**ADDENDUM NUMBER 2**

Issued: November 29, 2012

**North Bay Water Reuse Program  
 Sonoma Valley County Sanitation District  
 Napa Salt Marsh Restoration Pipeline  
 (Carneros Reservoir to Huichica Unit)**

FROM: Sonoma Valley County Sanitation District  
 404 Aviation Boulevard  
 Santa Rosa, CA 95403-9019

NAPA SALT MARSH RESTORATION PIPELINE GENERAL - KEY MAP	
FILE NAME: G-003.dwg	DRAWING NUMBER: G-3
CONTRACT NUMBER: -	SHEET 3 OF 19

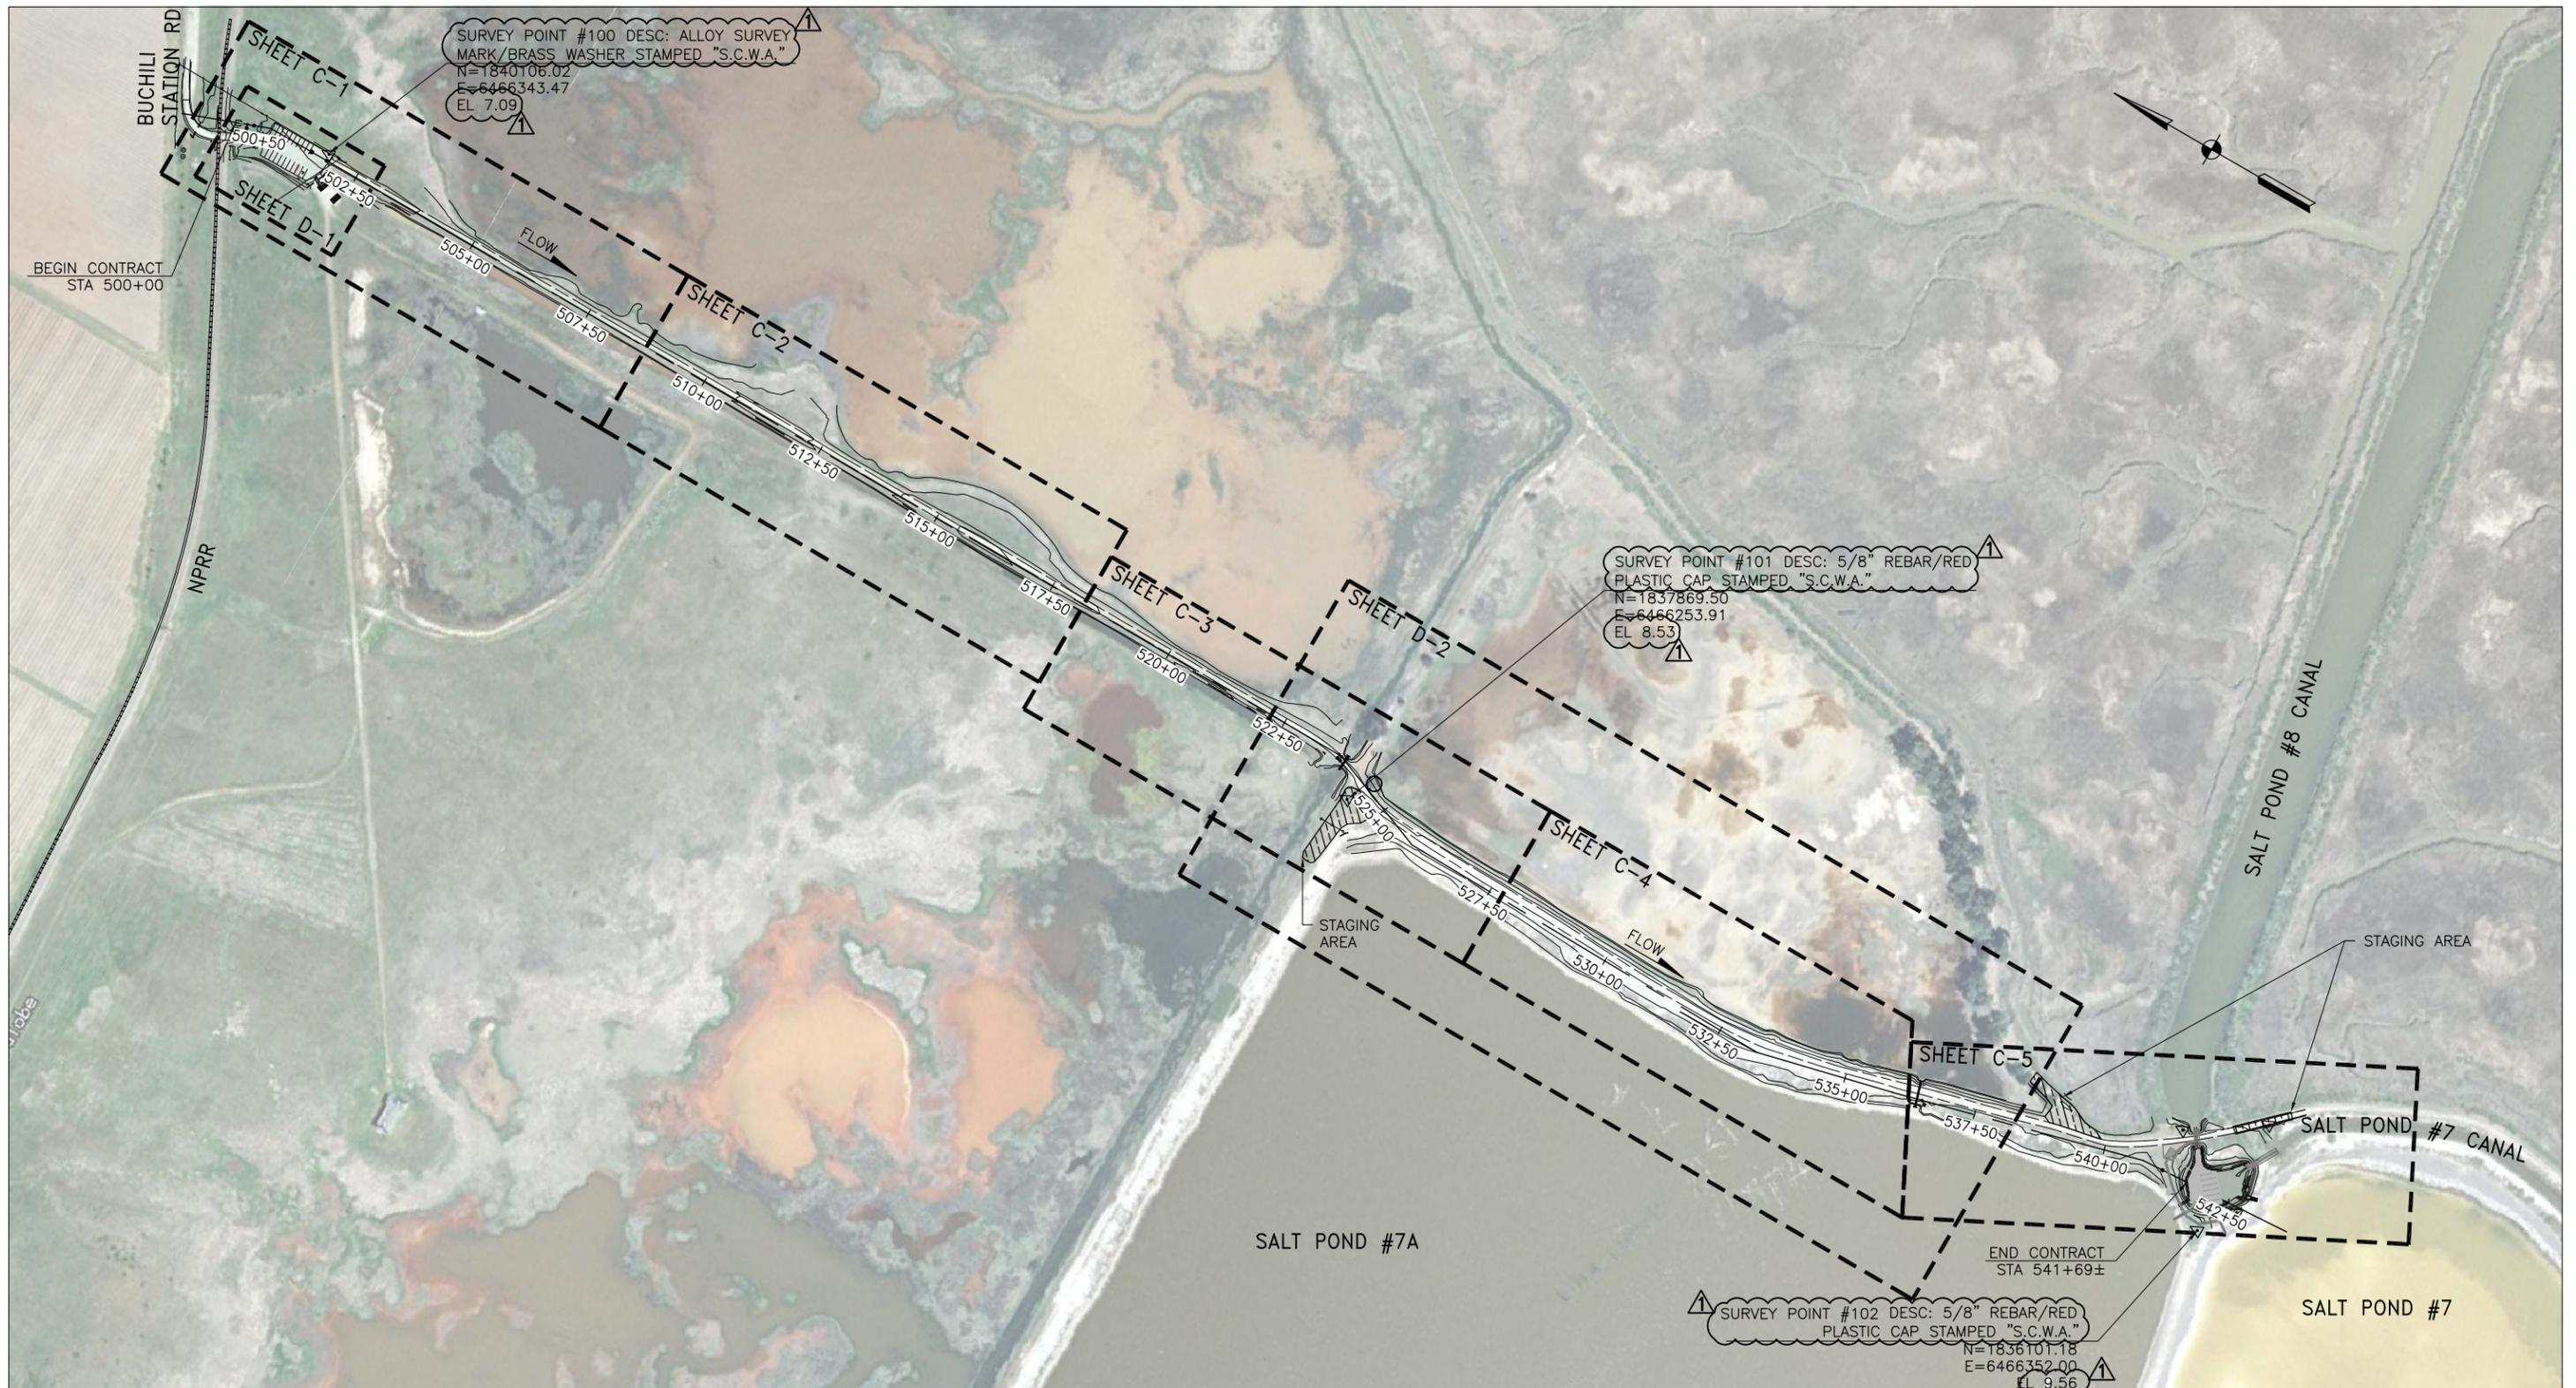
C. Delete Drawing No. G-3 and replace with Drawing No. G-3 attached and marked "11/27/12 Addendum 2"

DRAWING NUMBER: **C-1** SHEET 5 OF 19

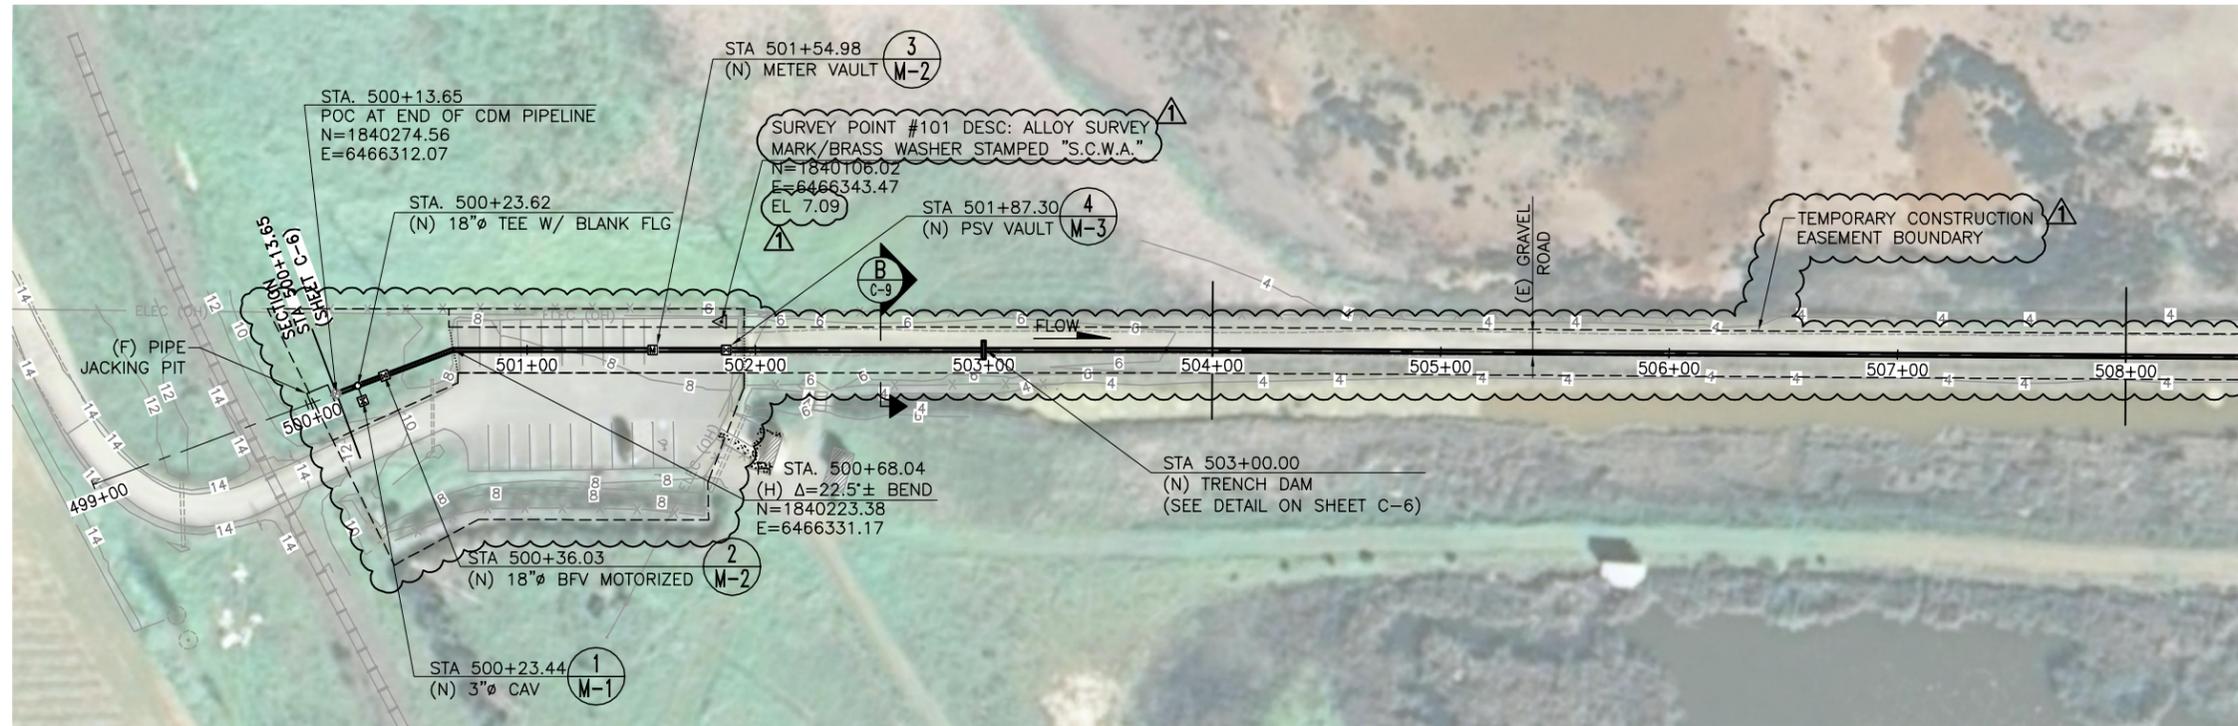
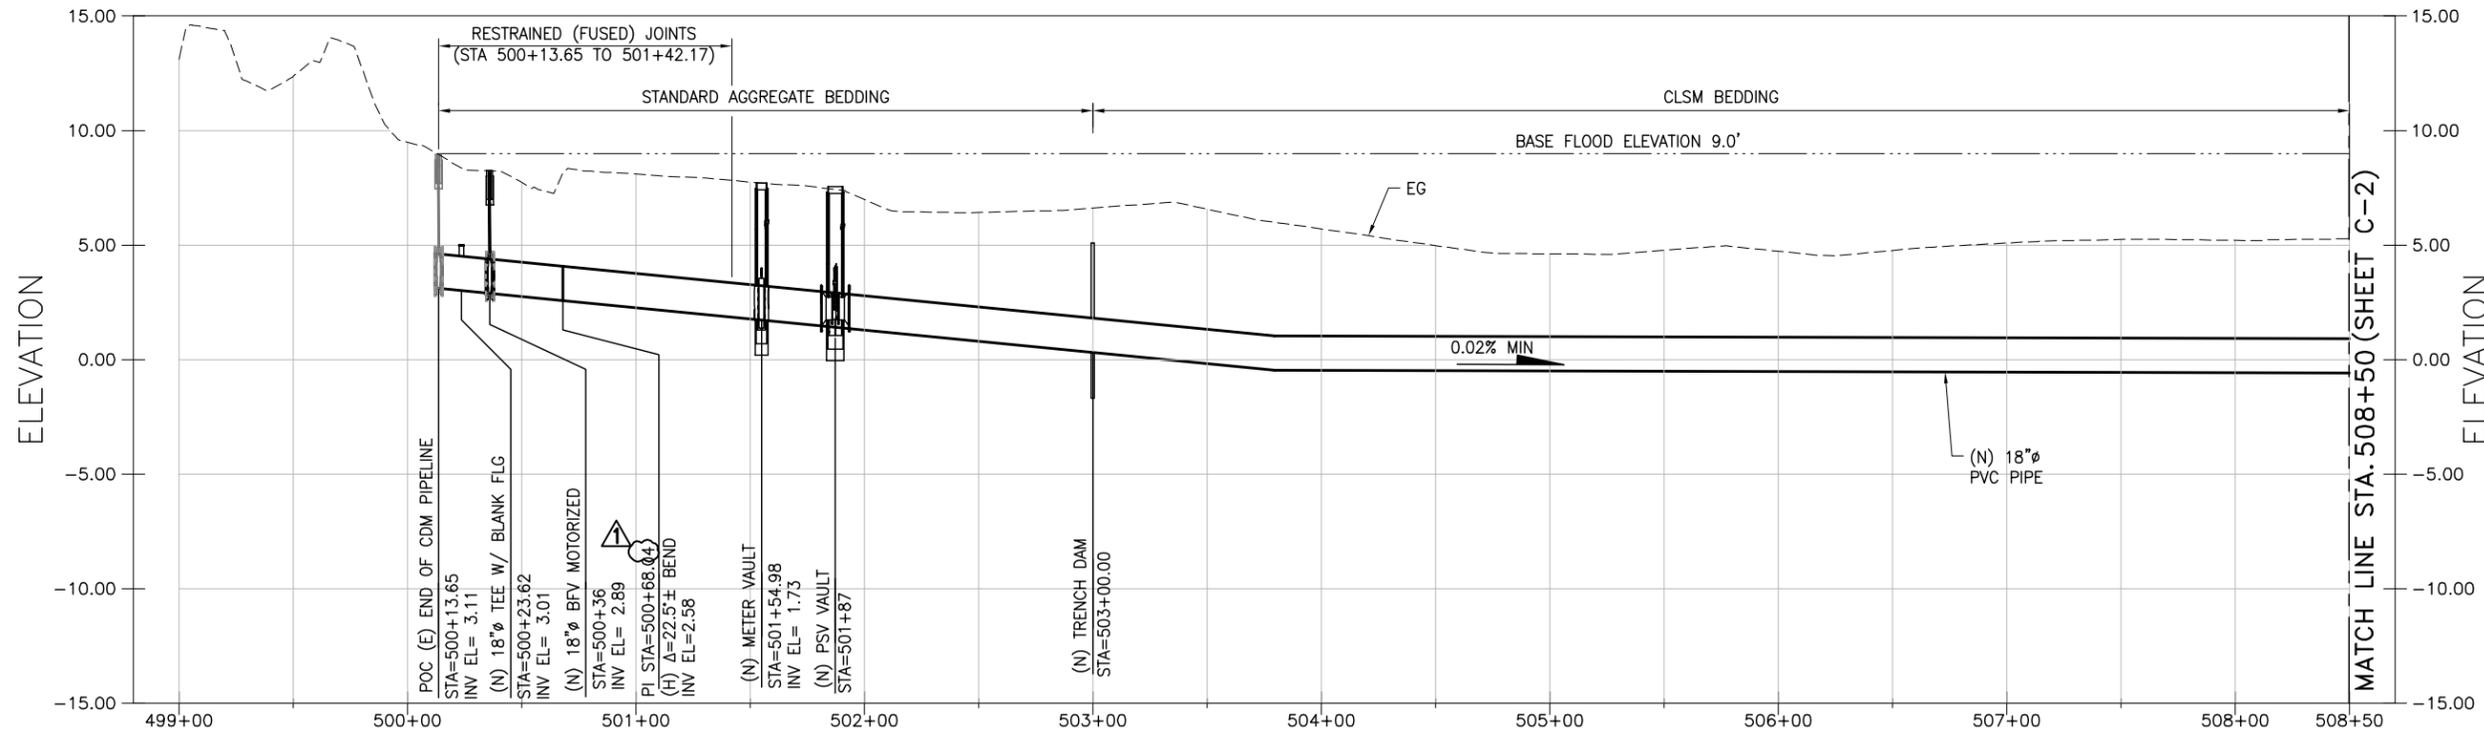
E. Delete Drawing No. C-1 and replace with Drawing No. C-1 attached and marked "11/26/12 Addendum 2"

FILE NAME: C-002.dwg	DRAWING NUMBER: C-2	SHEET 6 OF 19
CONTRACT NUMBER: -

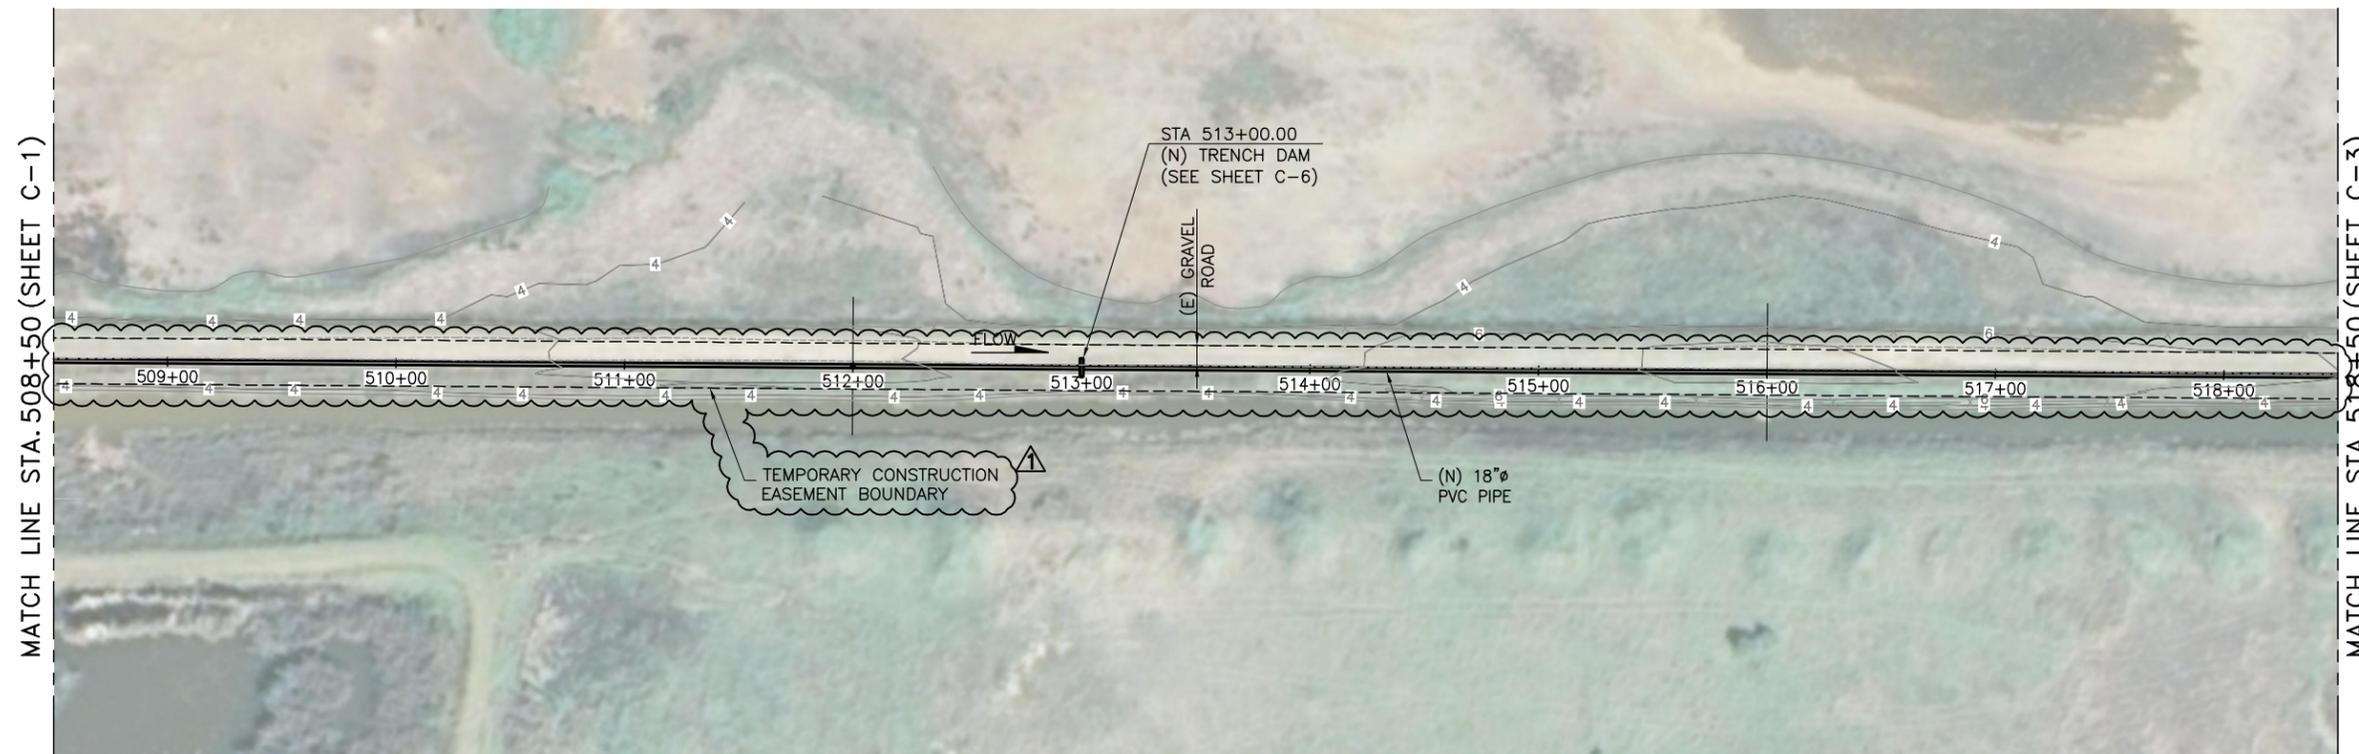
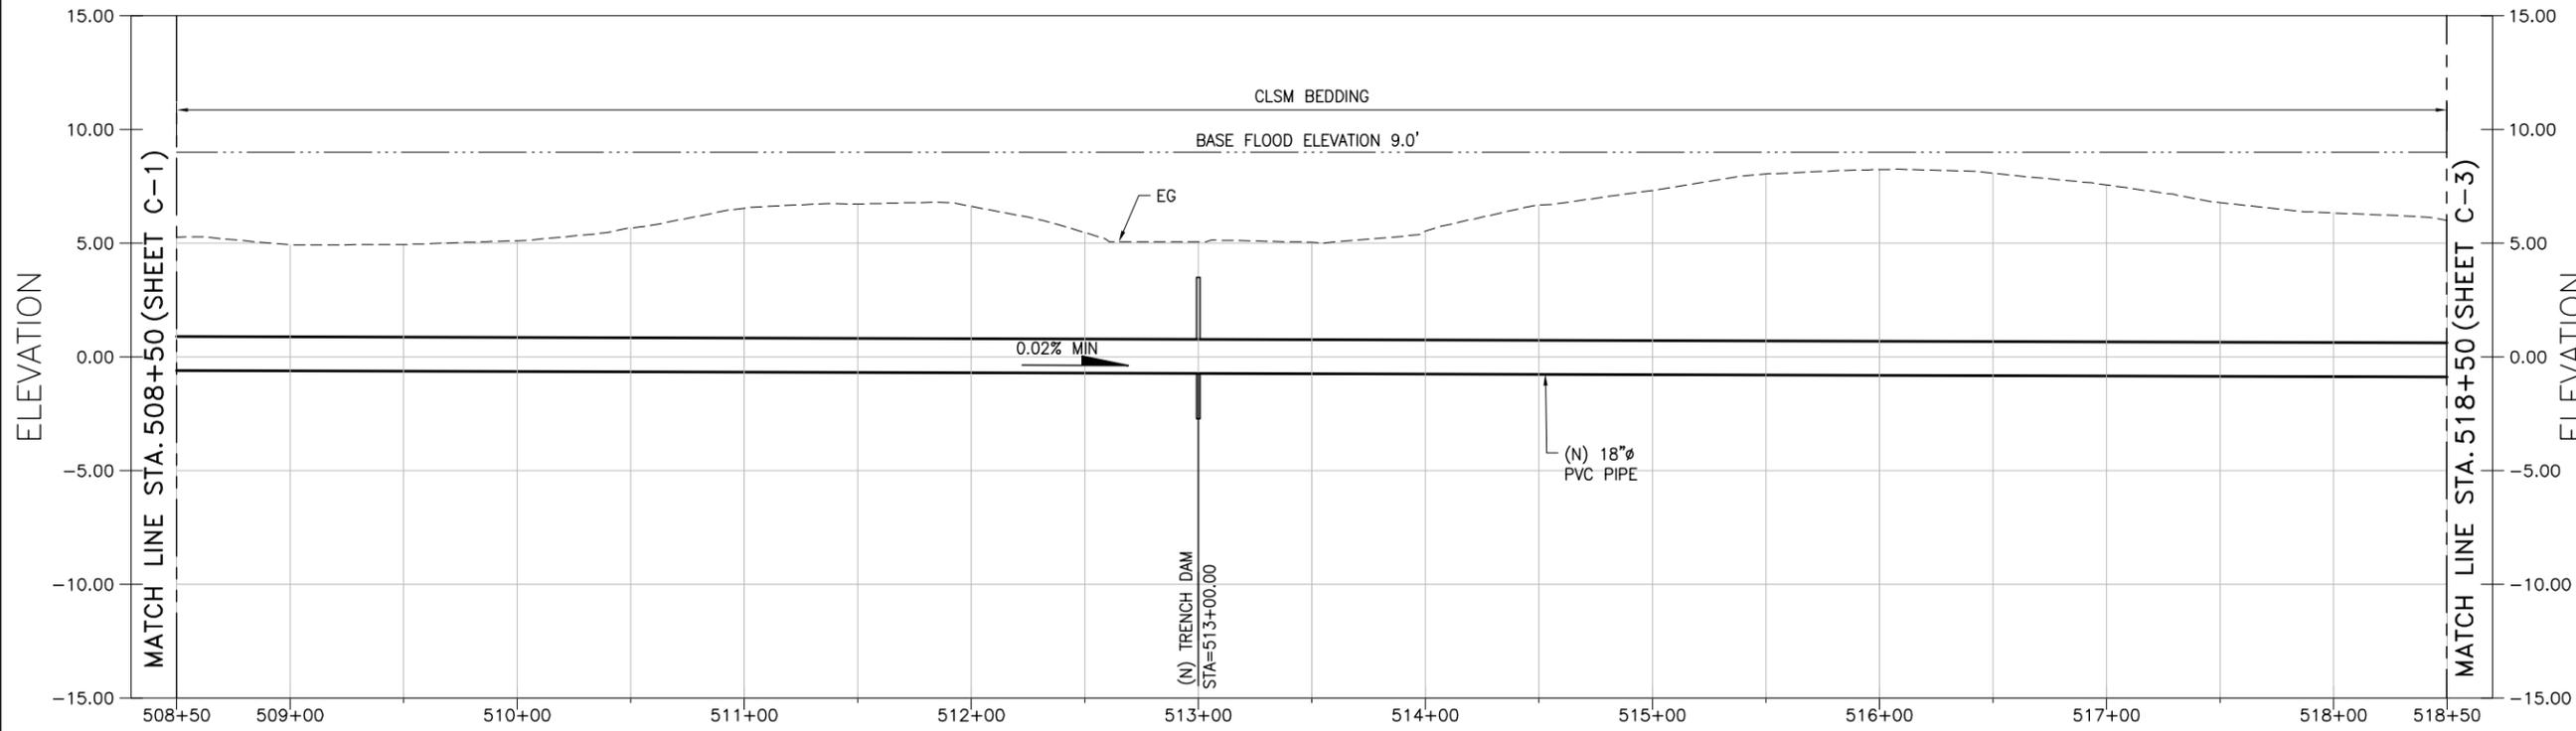
F. Delete Drawing No. C-2 and replace with Drawing No. C-2 attached and marked "11/26/12 Addendum 2"
